DTB

Date: April 23, 2009
 Order No.: S-B-03.30/08i
 Supersedes: S-B-03.30/08h dated October 24, 2008
 Group: 03

SUBJECT: Model 164.156/172/186/871/886
Model 171.454/456
Model 203.052/054/056/087/092
Model 204.054/056/081/987
Model 209.356/372/456/472
Model 211.056/072/087/090/256/287
Model 216.371/386
Model 219.372
Model 221.171/186
Model 230.471
Model 251.156/165
Equipped with M272 or M273 Engine
Check Engine Light On / Fault Codes Current and/or Stored in ME-SFI Control Module / Oil Leaking at Camshaft Adjustment Solenoid

Figure 1 – Damaged/worn S-B-03.30/08a

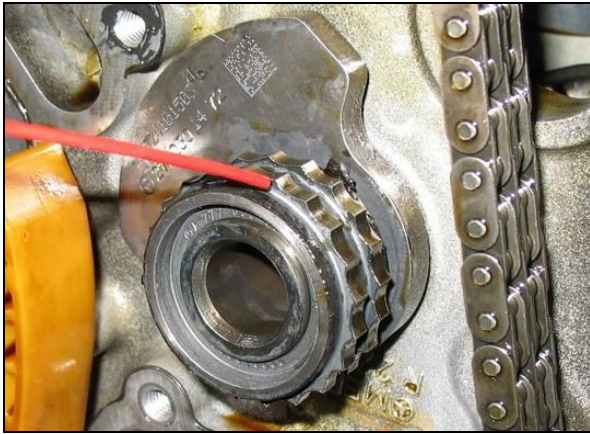
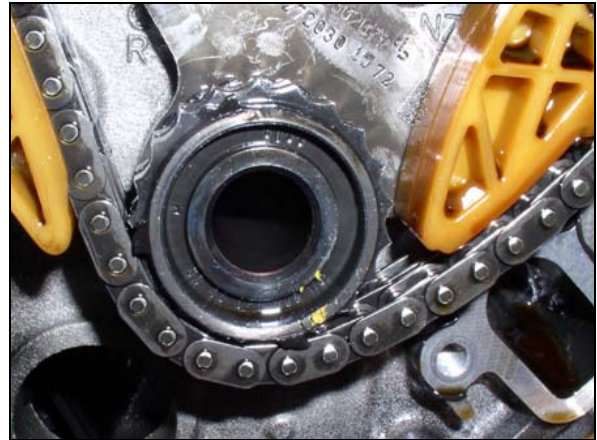
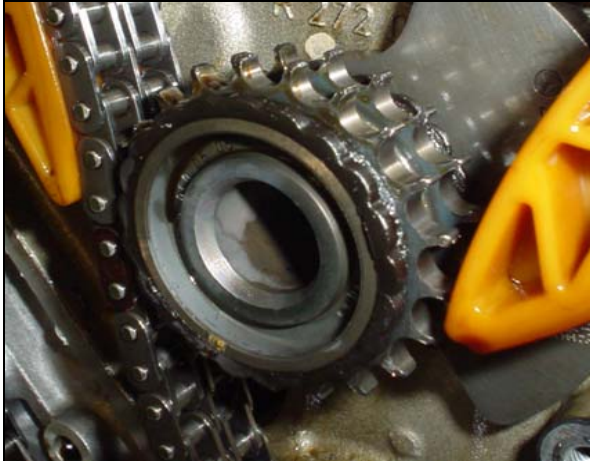
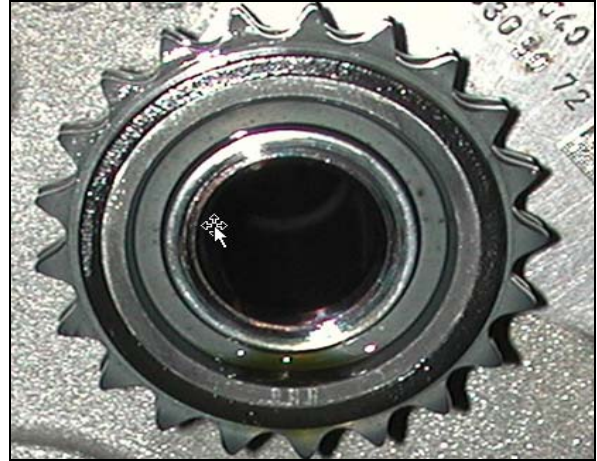
Fault Code Scenario 1: DTC 1200 and/or 1208 is/are present in ME-SFI control module. The fault codes are recorded as current and/or stored in the fault memory. When the fault memory is erased and the engine is restarted, the fault codes reoccur immediately. This is due to the positioning of the timing chain driven camshafts relative to the crankshaft and can be caused by a worn sprocket on the balance shaft on engine M272 or by a worn guide (idler) gear for the timing chain on engine M273. Figure 1, 2 and 3 show extremely worn sprocket gears. Figure 4, for comparison, shows a new sprocket gear.

- a) Perform a visual inspection for any wear of the teeth (damage profile) on the sprocket of the balance shaft (M272) or of the guide (idler) gear for timing chain (M273) by removing the timing case cover on the engine. Refer to WIS instructions AR01.40-P-8000* (* - applies to a specific model designation e.g. AR01.40-P-8000SX – models 221, 216). Ensure the use of the Special Tool W001 589 81 09 00 when removing / installing timing case cover.

i **Note:** Refer to Figure 1 through 3 for examples of damaged / worn sprocket profile. Refer to Figure 4 for example of a new gear (for comparison).

- b) Only if worn (sprocket teeth profile damaged), replace the balance shaft on engine M272 or replace the guide (idler) gear of the chain drive on engine M273 as per WIS instructions AR03.20-P-1000* (* - applies to a specific model designation e.g. AR03.20-P-1000VA – model 171).

Figure 5

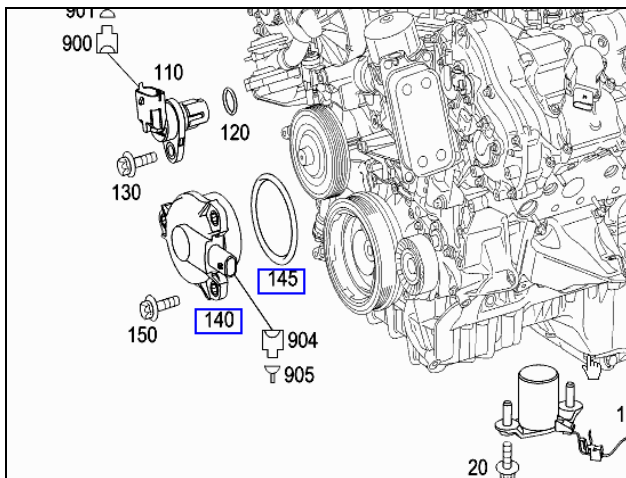
Fault Scenario 3: Camshaft adjustment solenoid is leaking oil, and no Fault Codes are current or stored in the ME Control Module. Determine the cause of the leak. The solenoid can be leaking from under the sealing ring or through the harness connector.

- a) If the leak appears to be between the solenoid and the cylinder head replace solenoid sealing ring (Figure 5, 145).
- b) If the leak is from the electrical connector, replace the solenoid (Figure 5, 140).
